HISTORIC PRESERVATION BOARD

HISTORIC PRESERVATION BOARD MEETING

PUBLIC HEARING
102 STATE STREET (Winter Street frontage)

WINTER STREET TOWNHOMES

1 WEST ELEVATION (YORK STREET)

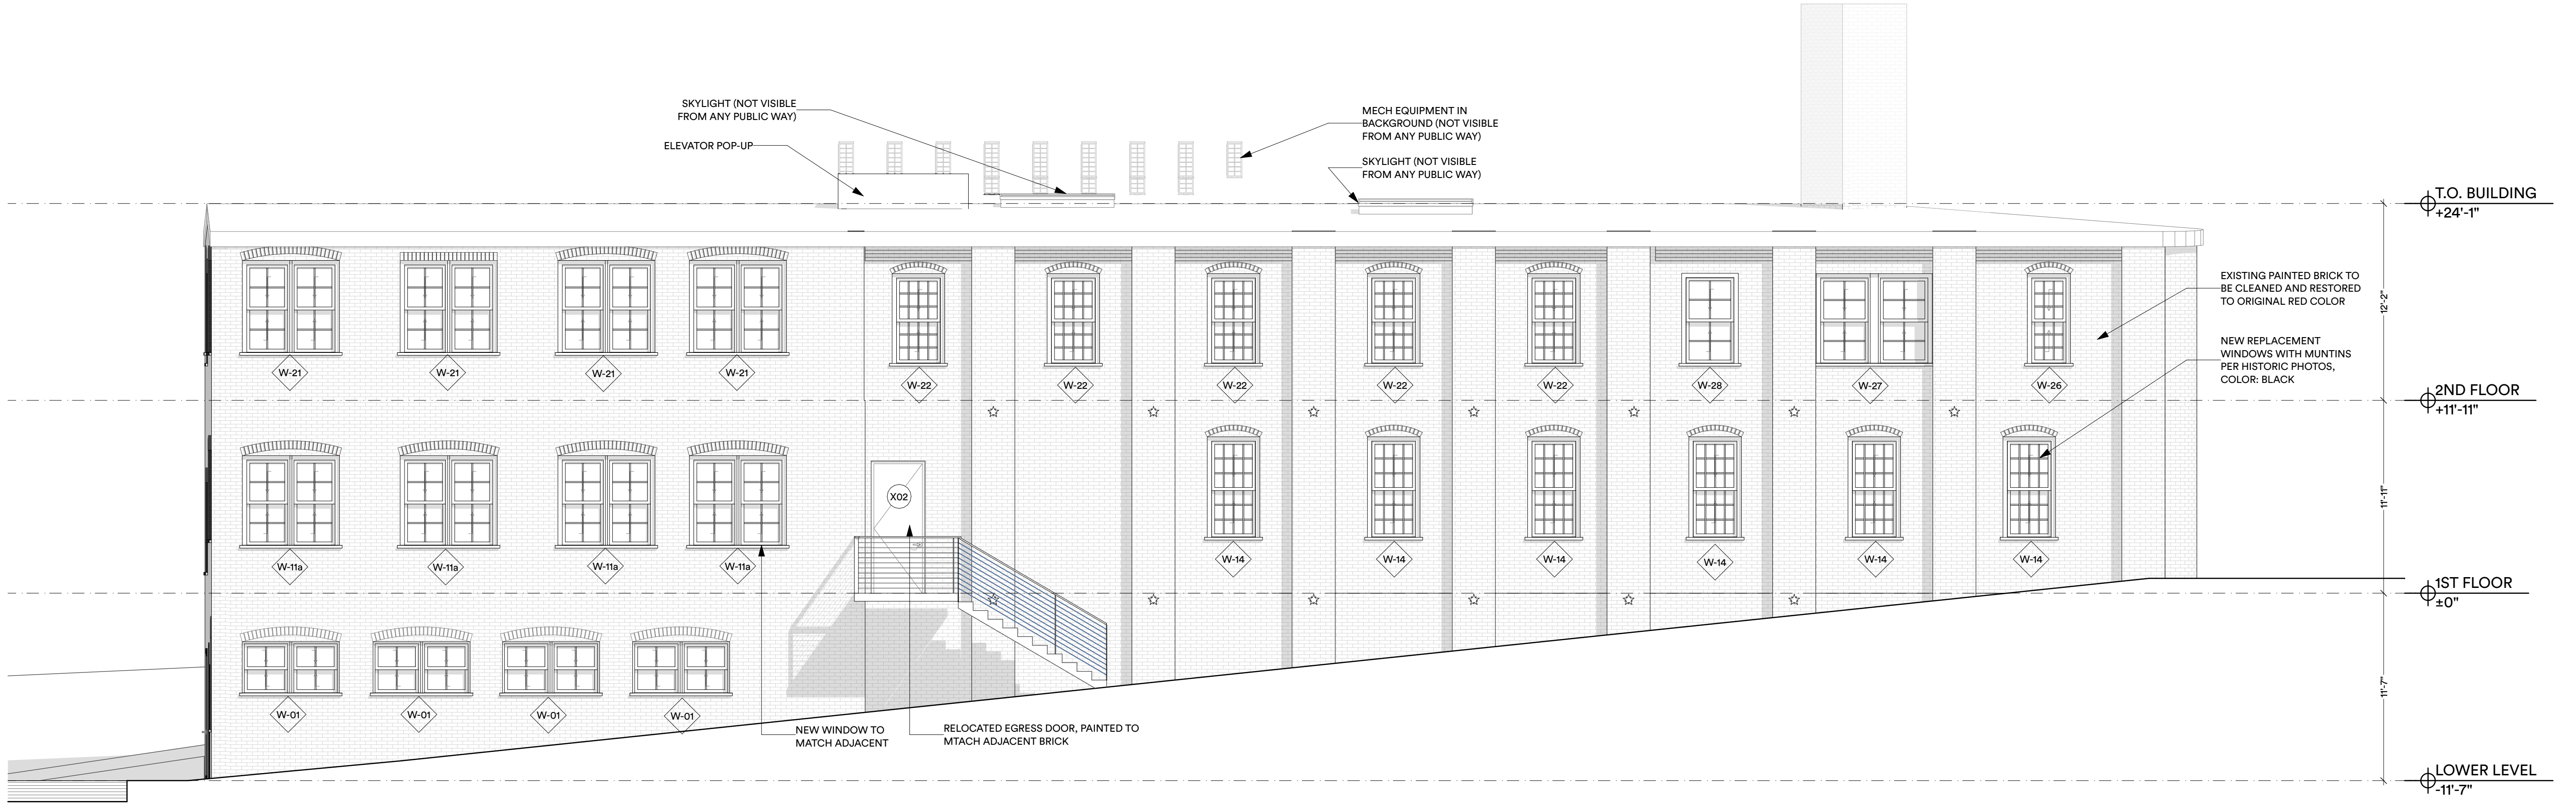
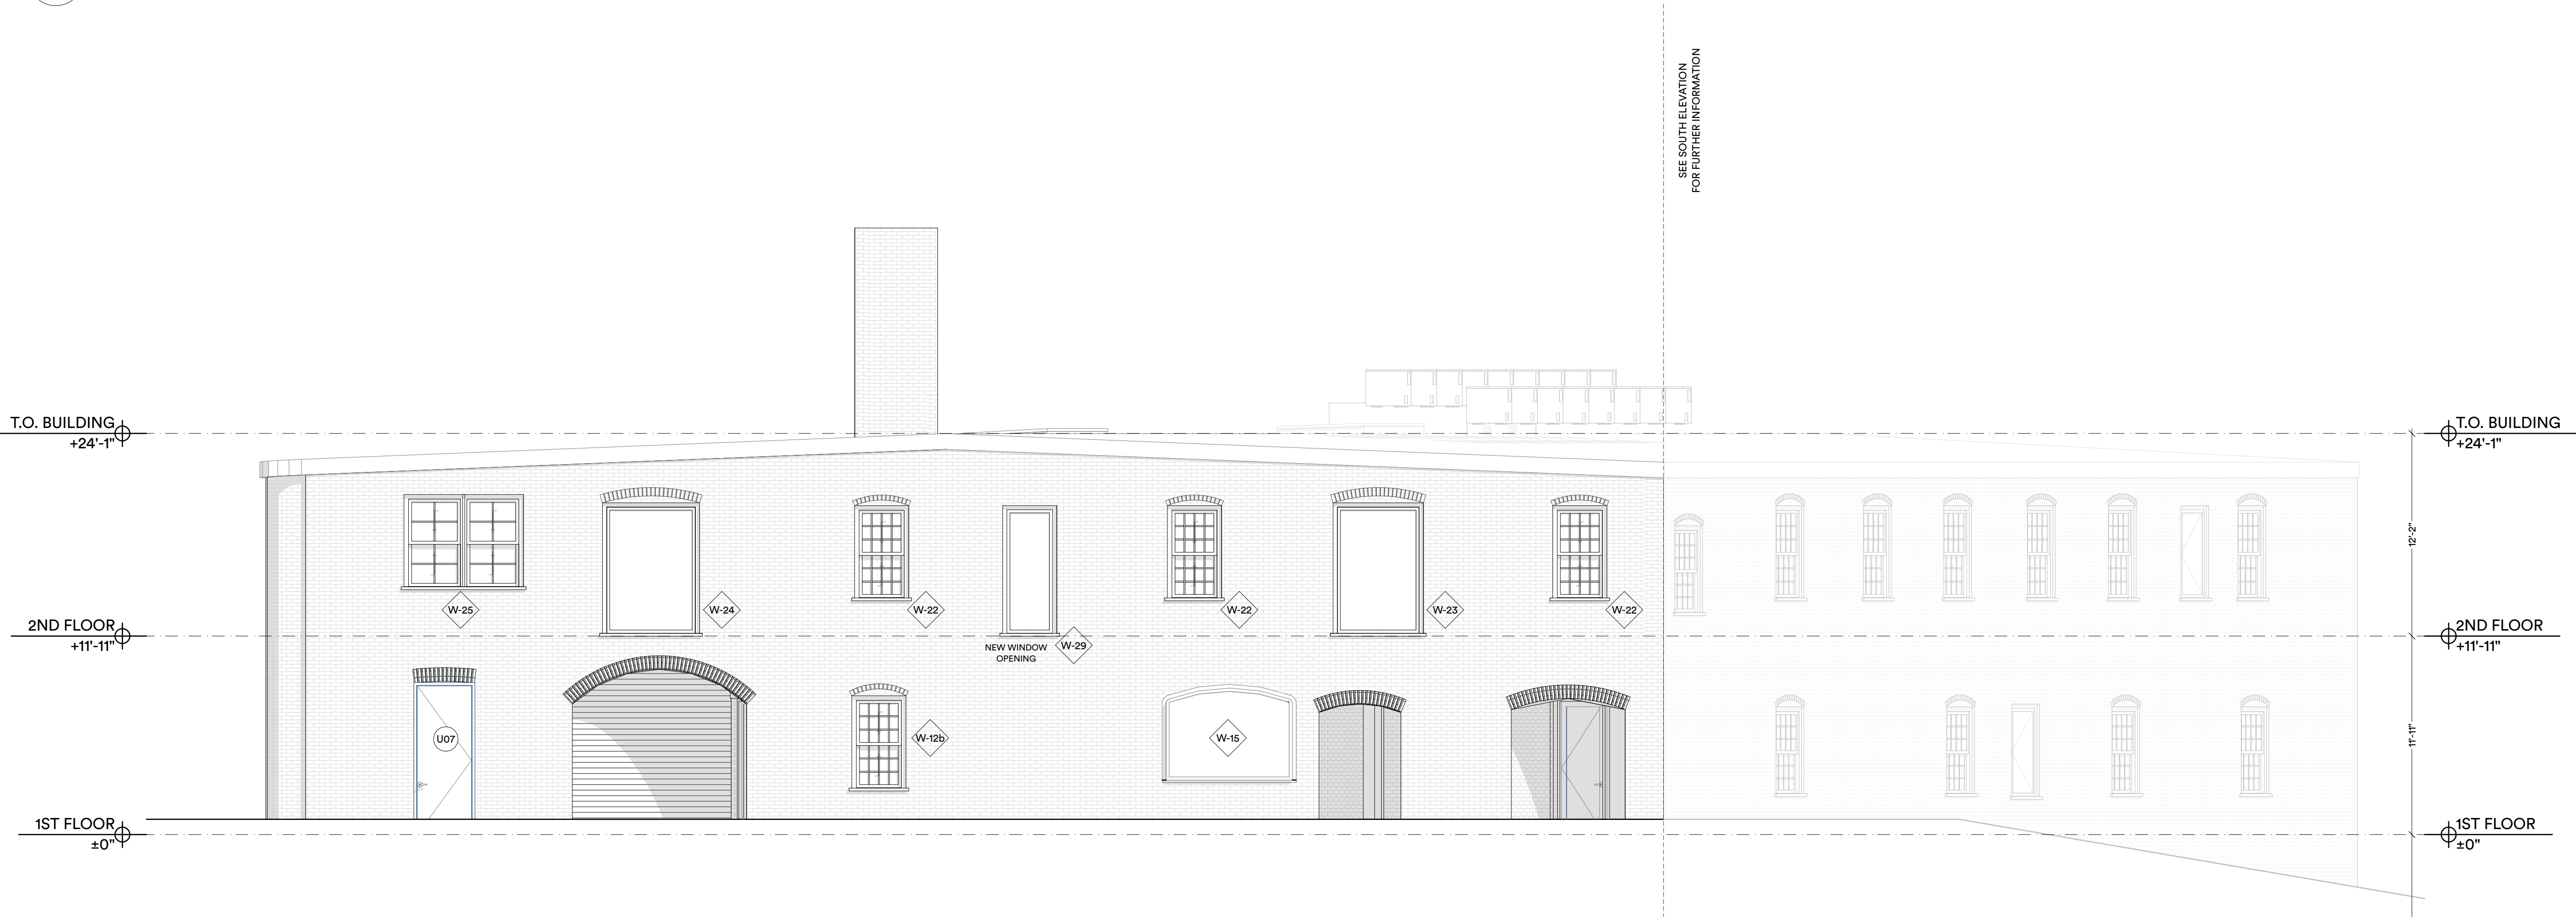
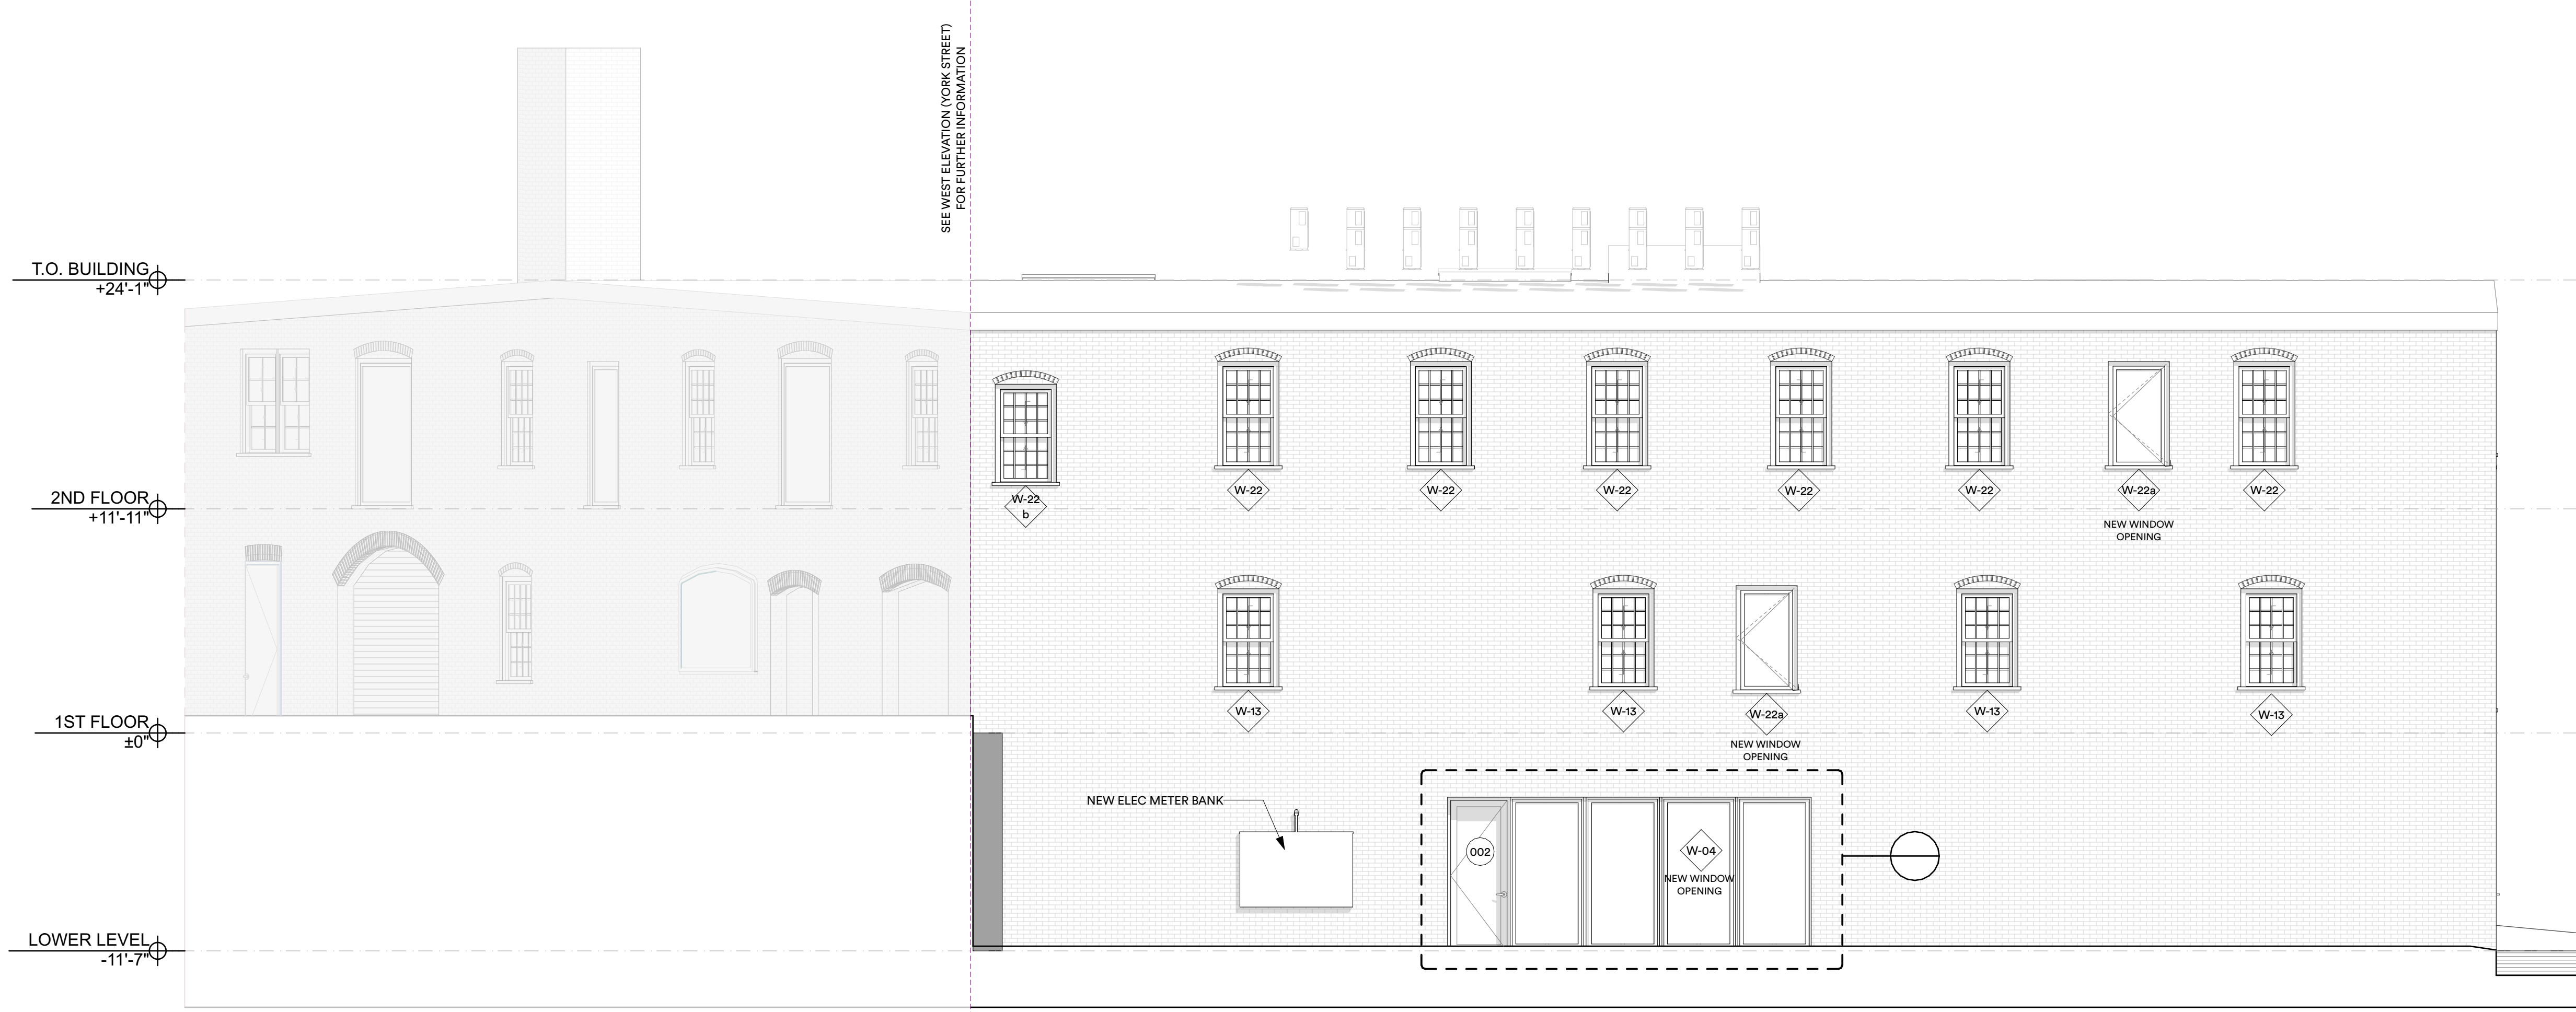
- Plans call for relocating the egress door on the Maple Street elevation, and modifying the existing metal stairs. A new window is to be added in the former door location.

- It is noted that the variety of window types seen on the elevations, designed in consideration of differentiation of new openings, freight openings, and later additions, makes for a somewhat irregular pattern of fenestration. It appears to be what is needed to satisfy the review standards; staff does not know whether alternate, more subtle ways of communicating the distinctions between the openings can be found, but it must be assumed that the consultant, the owner, the architect, and the state Preservation Commission reviewer have examined the options in some detail.
